7. **Case #H-16-073A. 320 Paseo de Peralta.** Downtown & Eastside Historic District. Santa Fe Sustainable, agent for FFT LLC, owner, proposes to replace windows and construct a 168 sq. ft. portal on a non-contributing, non-residential structure. (Nicole Ramirez Thomas)

City of Santa Fe  
Historic Districts Review Board  
Findings of Fact and Conclusions of Law

**Case #H-16-073A**

**Address** – 320 Paseo de Peralta

South elevation of patio

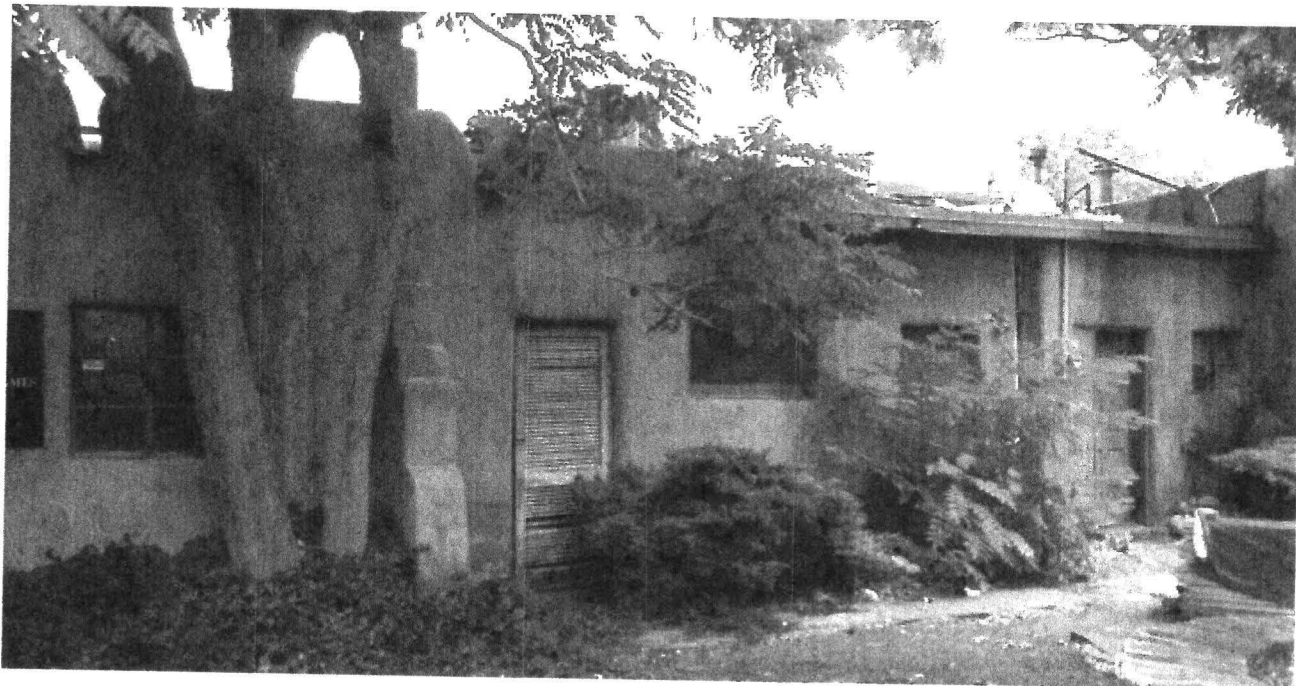
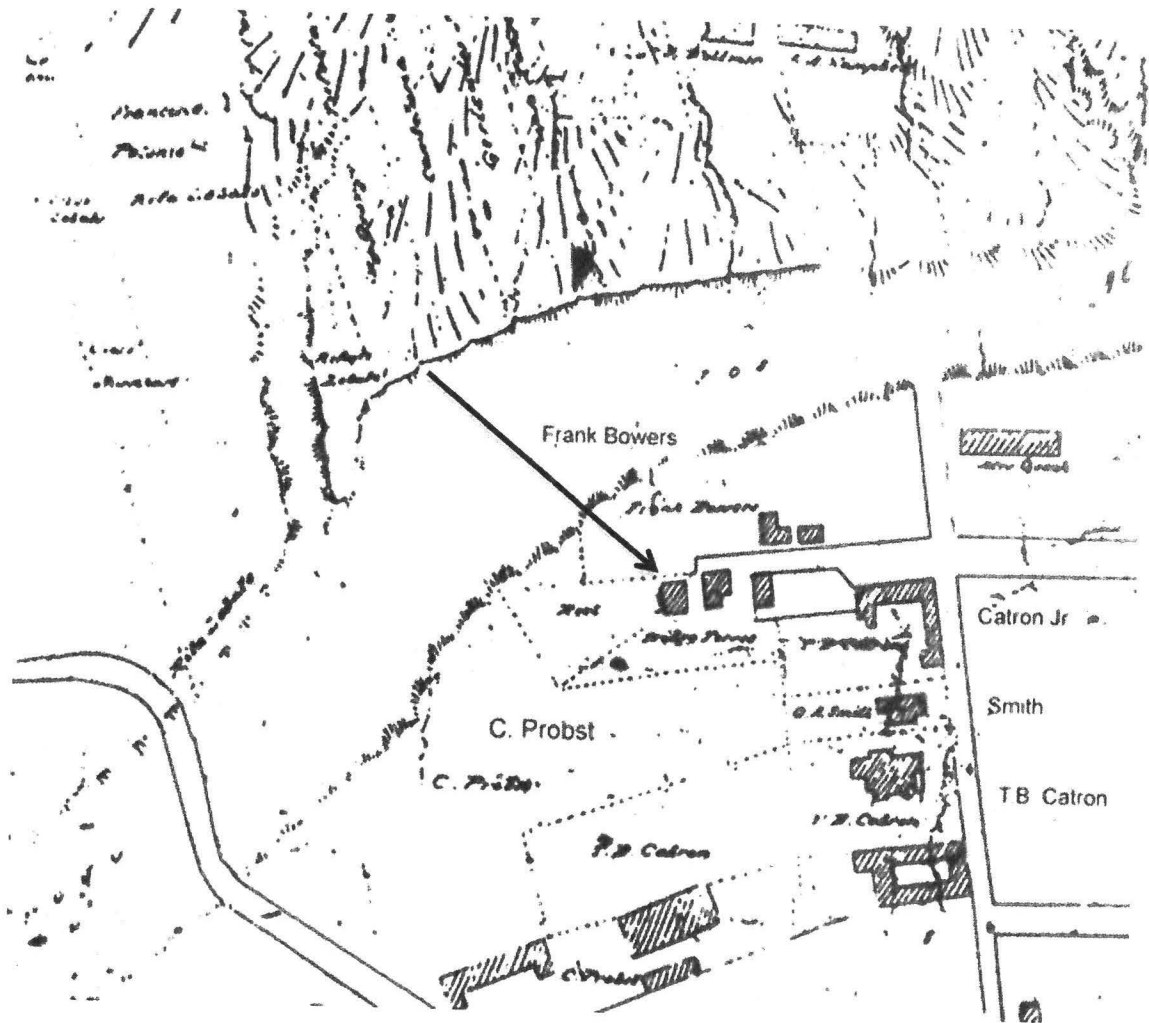
Note diagrams above right; Only the portion with the steel sash window at left was present in 1958 and still remained in 1973.

EXISTING NORTH ELEVATION  
"WINDOWS"

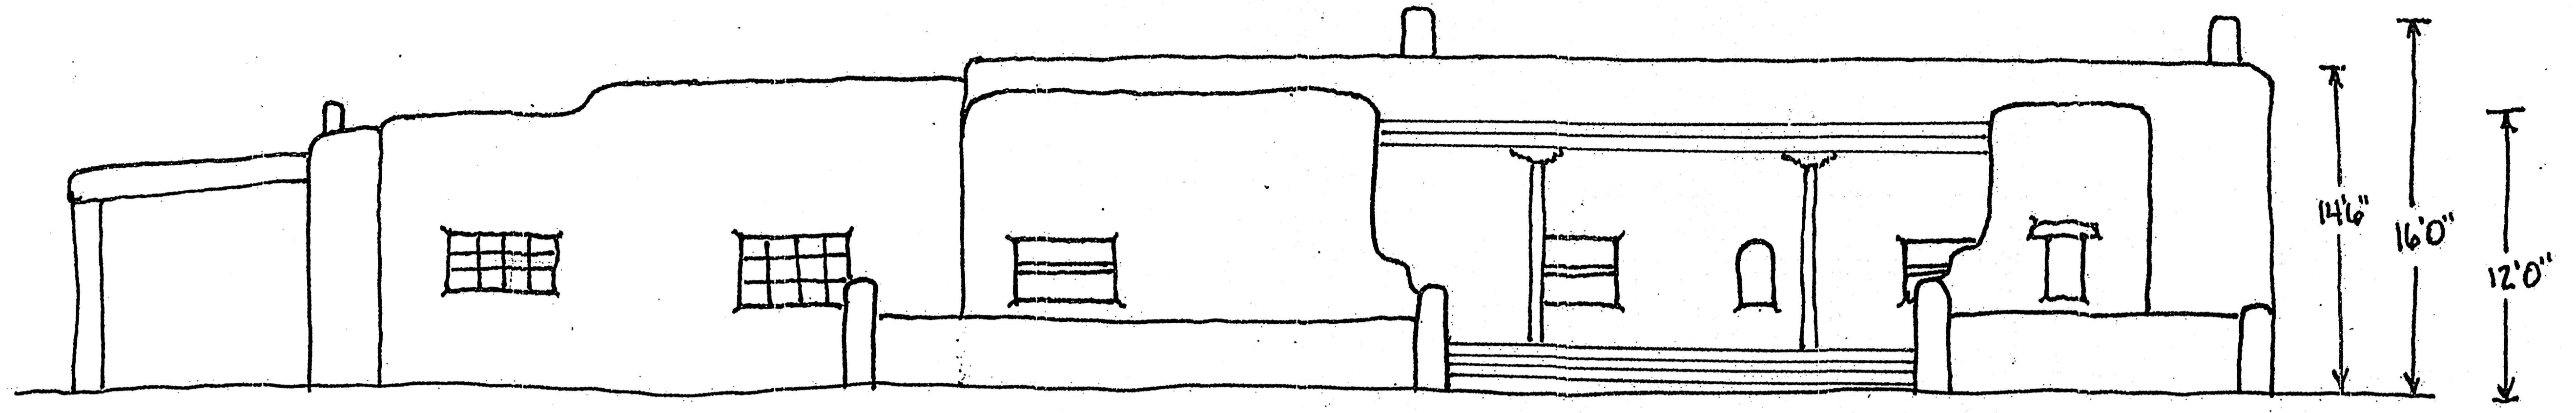
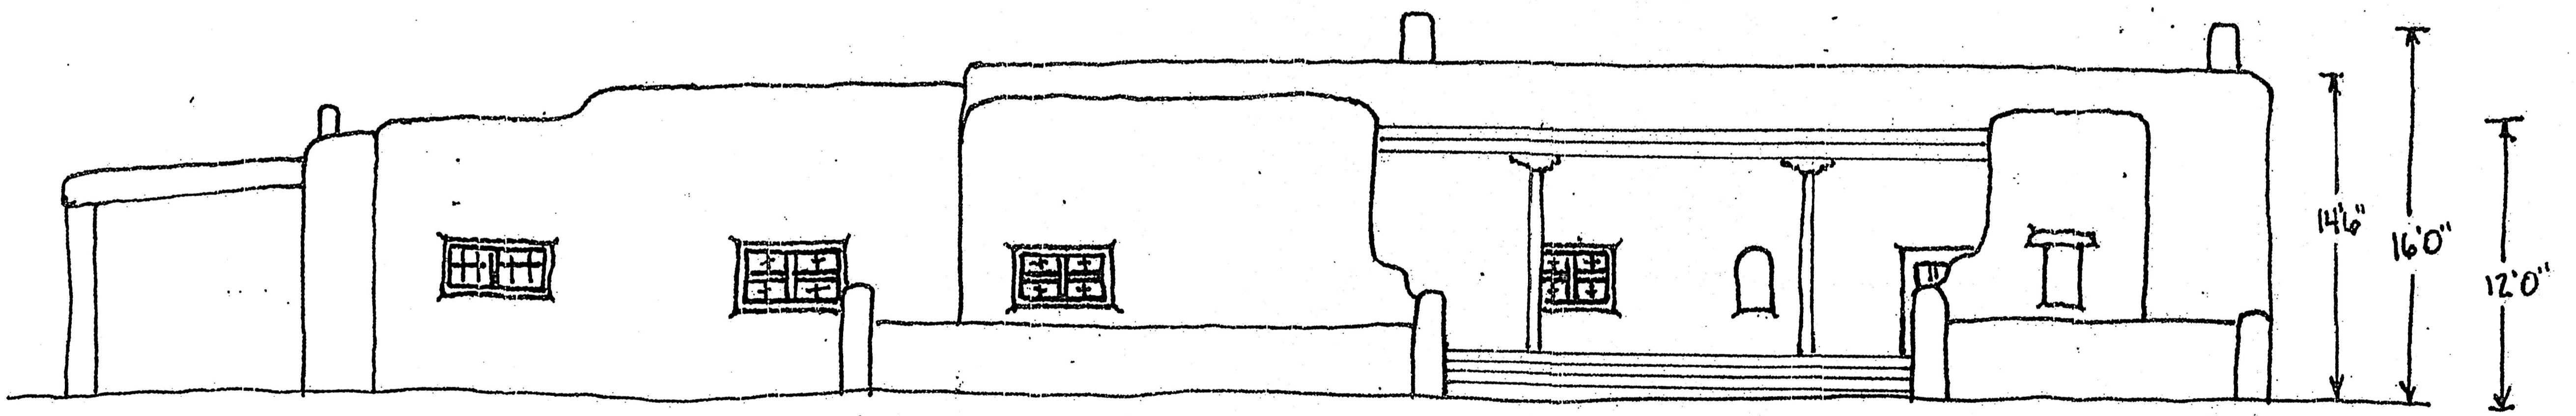
- a) Replace all windows on the north elevation.
- b) Replace a window for a door on the south elevation.
- c) Replace one window on the south elevation.
- d) Removal of a door opening on the south elevation.
- e) Replace two windows for two doors on the east elevation.
- f) Replace two existing doors on the east elevation.
- g) Replace two windows on the east elevation.
- h) Replace all windows on the west elevation.

PROPOSED PORTAL ELEVATION  $\frac{1}{8}'' = 1'0''$   
"WINDOWS"  
SOUTH

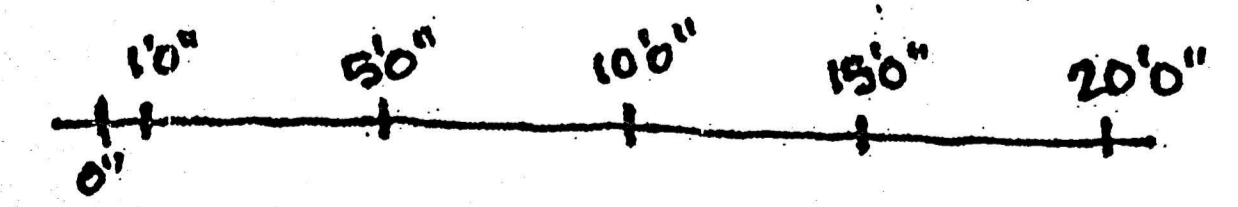
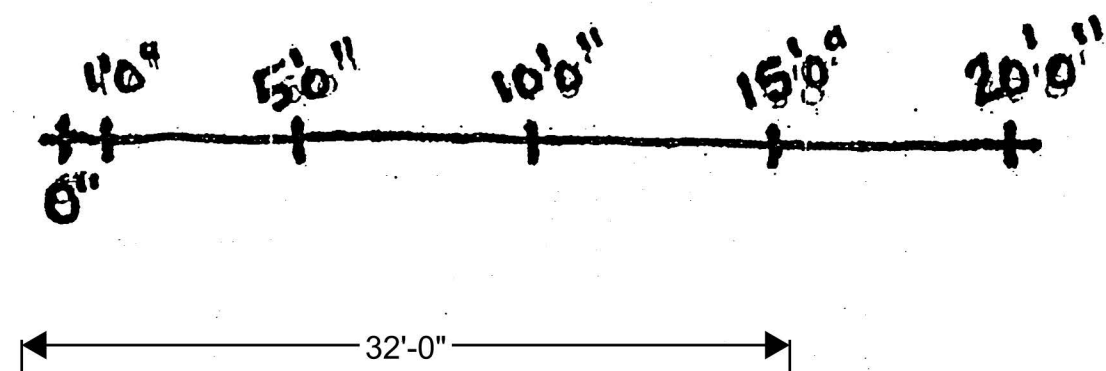
1) Add a 168 square foot portal to the south elevation of the structure to a height of 8 feet. Trees near the building will remain.

EXISTING WEST ELEVATION  
"WINDOWS"

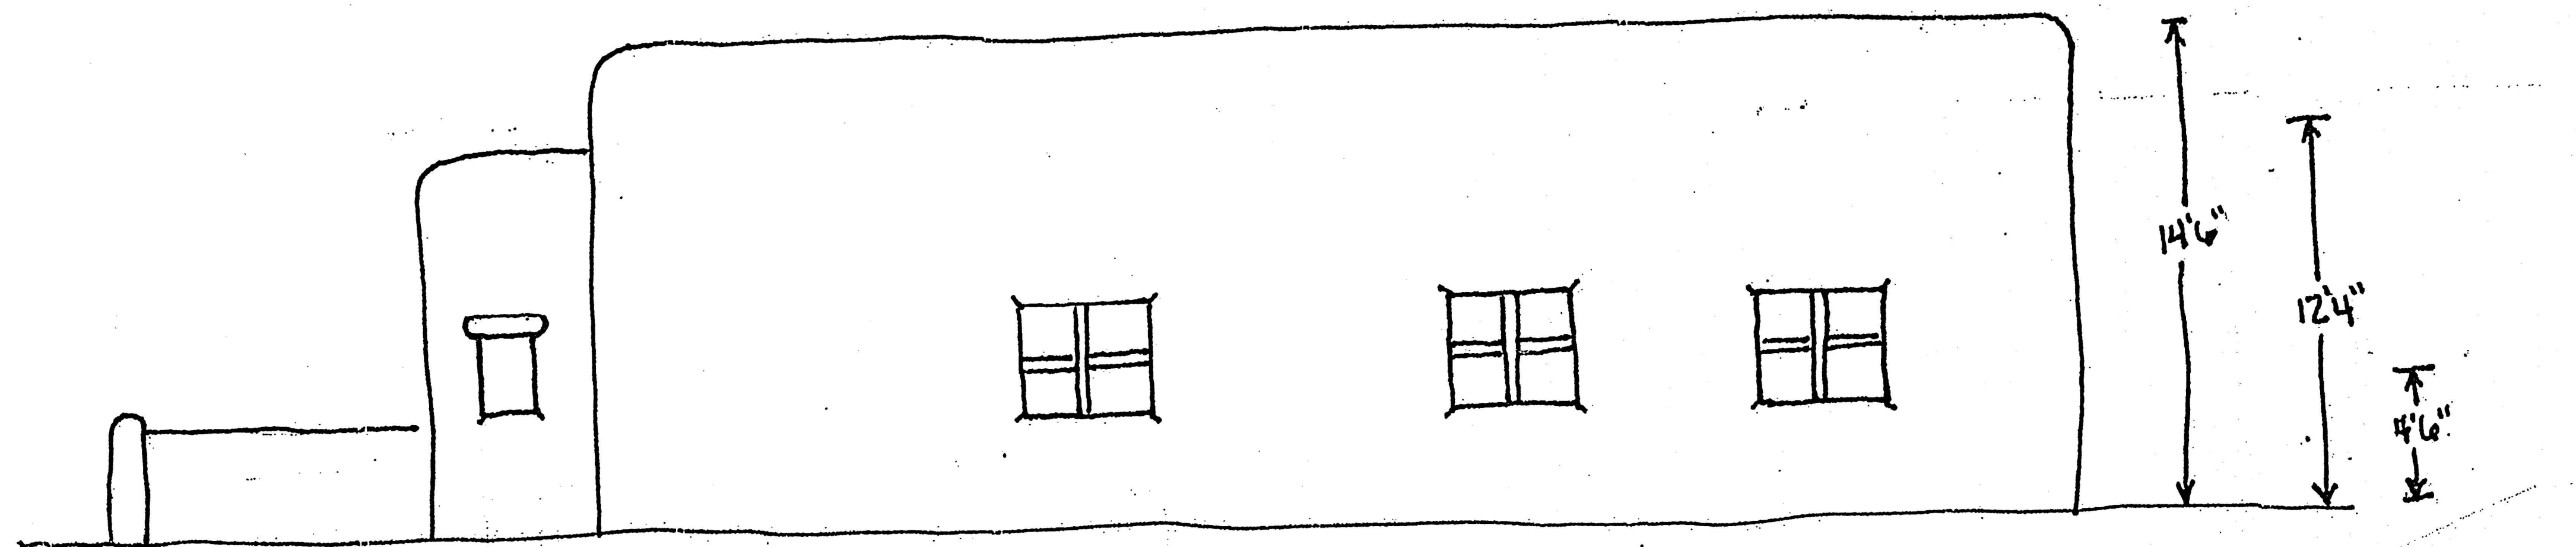
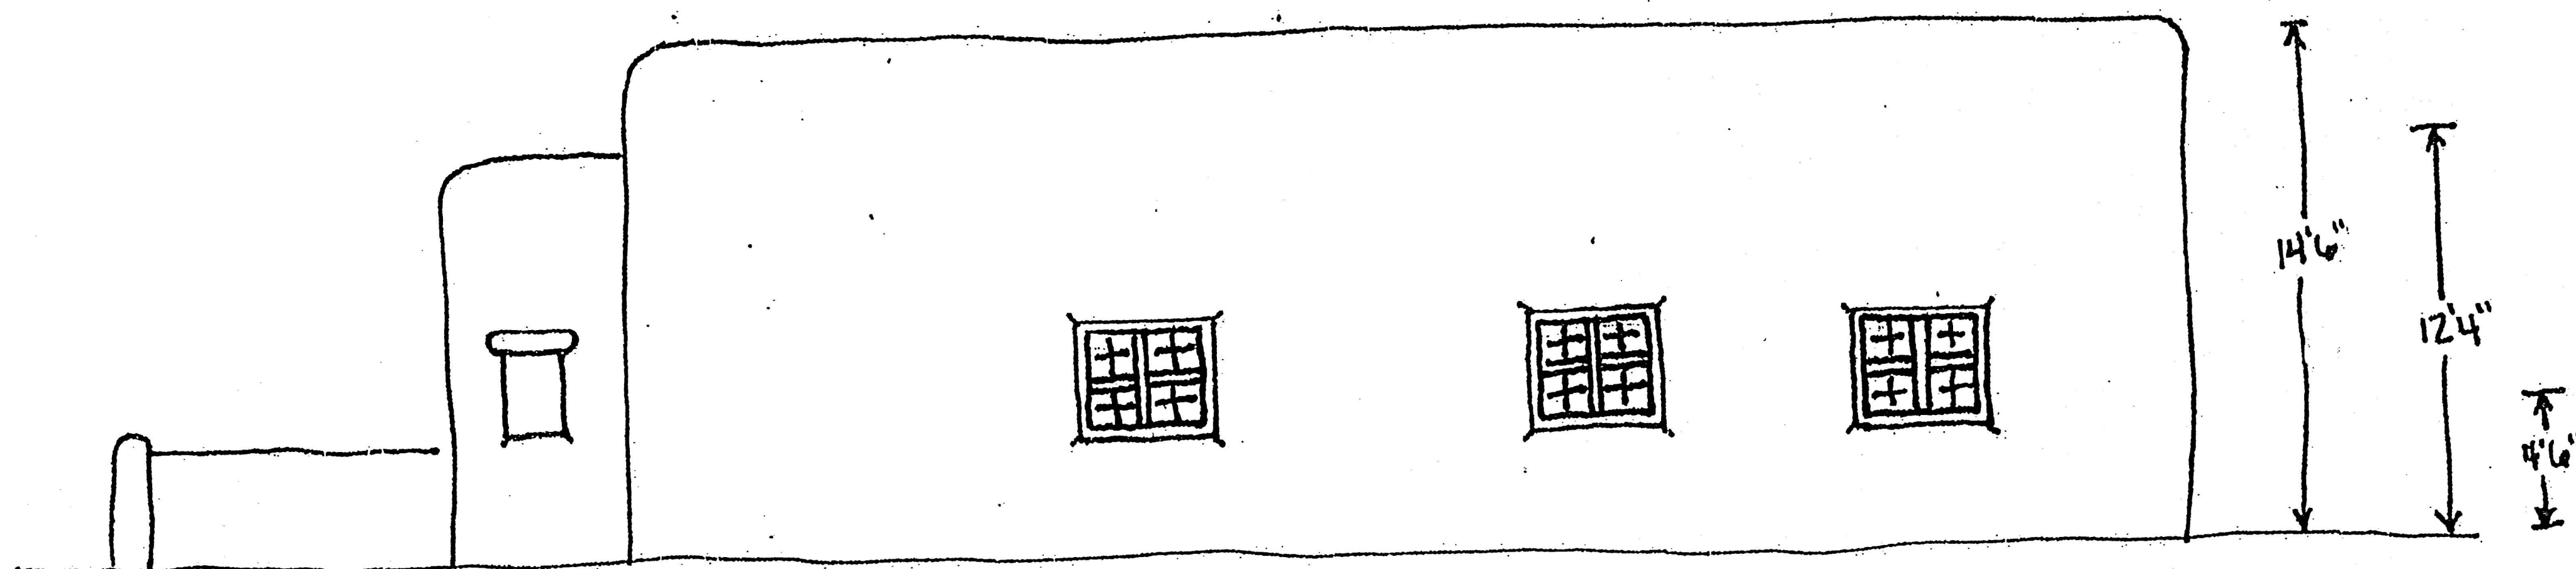
Chair Rios asked what the proposed lite pattern is on the west.

Mr. Rasch said it is four over four.
